# STAR ONLINE PUBLICATION

**Case Number:** S210800002 REV. A

**Symptom/Vehicle Issue:** In Extremely Cold Temperatures The Customer May Complain Of An Intermittent No Crank, Cranks And Stalls, Stops Cranking Fails To Start

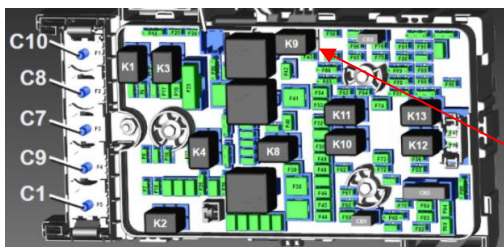
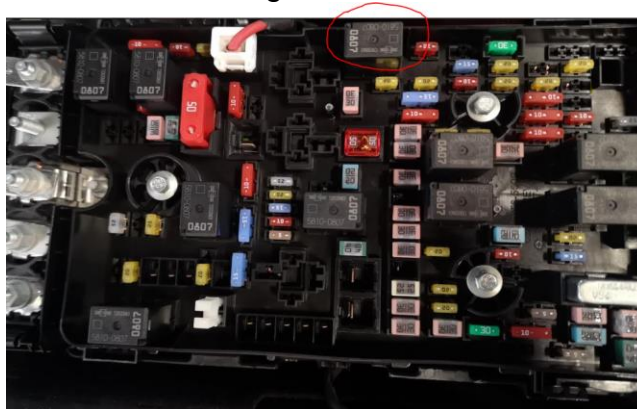
**Customer Complaint/Technician Observation:** Owner complains in extremely colder temperatures the vehicle may exhibit a No Start or and/or a Start and Stall fail to Start condition. Vehicle will start normally when PDC or vehicle is warmed up. This symptom may also be accompanied by DTC, P1279 - STARTER CONTROL CIRCUIT 2 OPEN.

**Repair Procedure:** Inspect the Run/Start relay in the PDC and confirm it is manufactured by "Song Chuan" vehicle built after September 2019. Replace the Song Chaun relay with the service replacement part (Denso 68406797AA). Verify the vehicle starts and does not stall and no DTC's are setting. If the issue has been resolved, no further action is needed. If the condition persists, follow the published service procedures to further diagnose the issue.
